REGIONAL REVIEW FINDING

ARC REVIEW CODE: R1708151

Name of Proposal: Friendship Village (DRI 2686)

FRIENDSHIP VILLAGE DRI
City of Atlanta
Natural Resources Group Review Comments

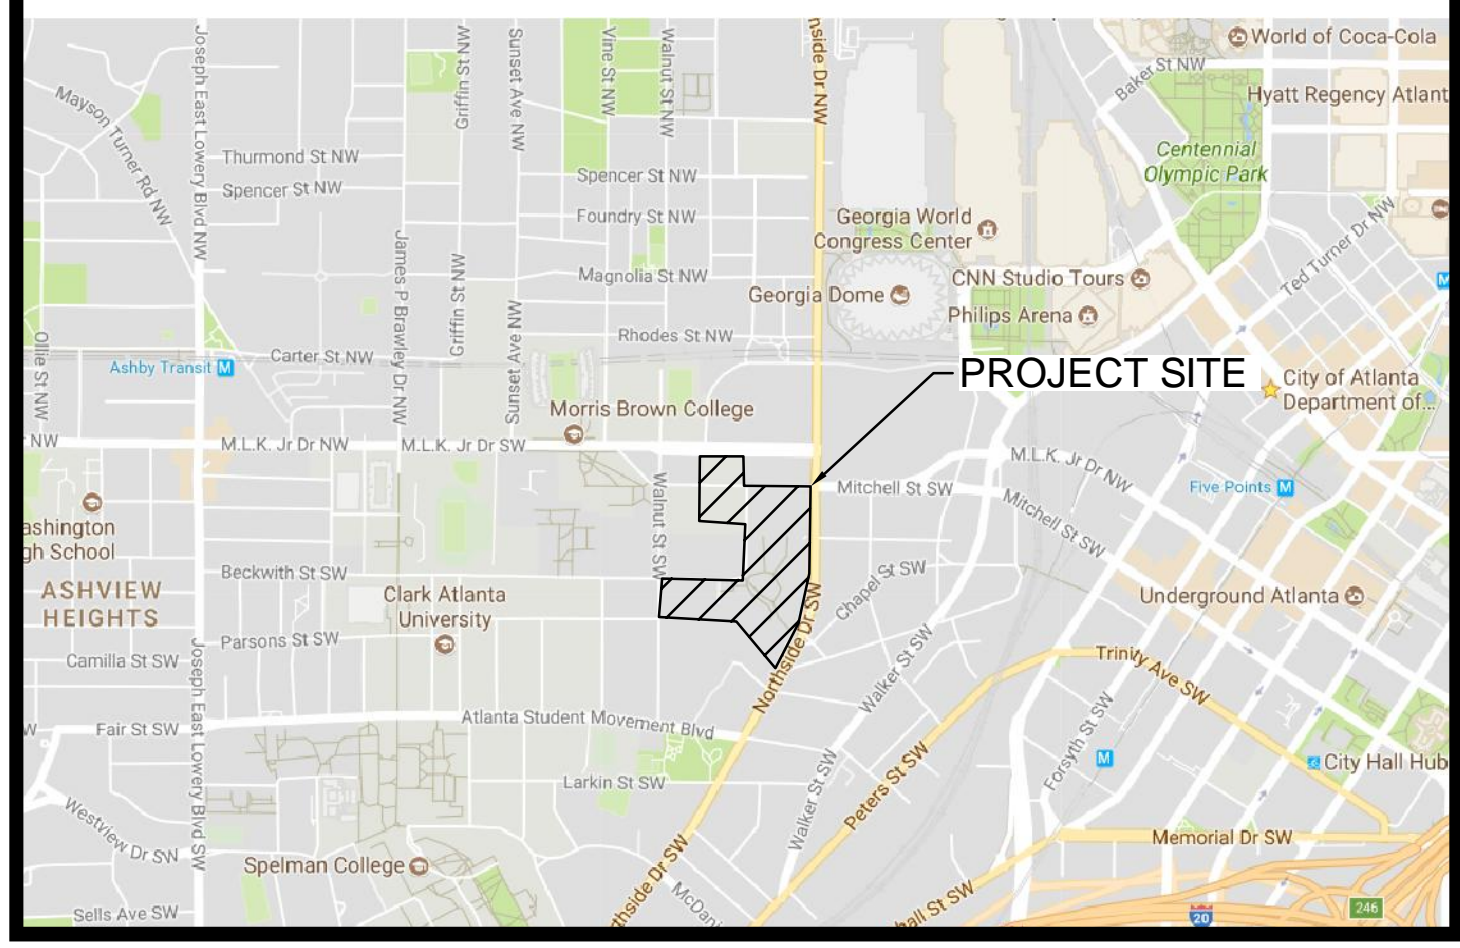
The density of this DRI generally aligns with the RDG's recommended range of densities in Maturing Neighborhoods. The proposed number of stories for buildings on the two blocks fronting Northside Drive, south of Mitchell Street (Blocks D and F on the site plan), are greater than what the RDG recommends – although it should be noted that these buildings are directly across Northside Drive from the Region Core area, which recommends buildings of that height and greater. In general, the project's mixed-use character and intensity are similar to other new development in the Region Core, some of which is being spurred by the construction of Mercedes-Benz Stadium. However, some nearby areas are predominated by single family residential uses. City of Atlanta leadership and staff, along with the applicant team, should therefore collaborate to balance the goal of new development with the need for sensitivity to nearby land uses.

The transportation analysis and site plan shows proposes eleven driveways throughout the site providing inter parcel connectivity.

The site plan and traffic analysis shows proposed pedestrian improvements to existing facilities and construction of new facilities internal to the site allowing for internal pedestrian connectivity

The development proposes additional Access points at Driveway 1 on Walnut Street, Driveways 5, 6, 7 and 8 on Northside Drive and Driveway 9 and 10 on Martin Luther King Jr Drive. Driveway access 8 does not align with the existing access point on Nelson Street presenting safety concerns. Proposed Driveway access 6 creates conflicts with existing access points on the east side of Northside Drive.

A senior housing component was initially proposed for this development. Although the senior housing component was discussed during the Pre Review meeting and at subsequent meetings with the City, the site plan and traffic analysis does not specify its location. The site does indicate a single story residential component with in Block G on the corner of Walnut Street and Beckwith Street that may be planned for Senior Housing. Considering the allotted maximum alt mode reduction and the need to encourage transit ridership, ARC would encourage locating the senior housing element as close as possible to public transportation and other neighborhood amenities such as grocery stores and retail shops.
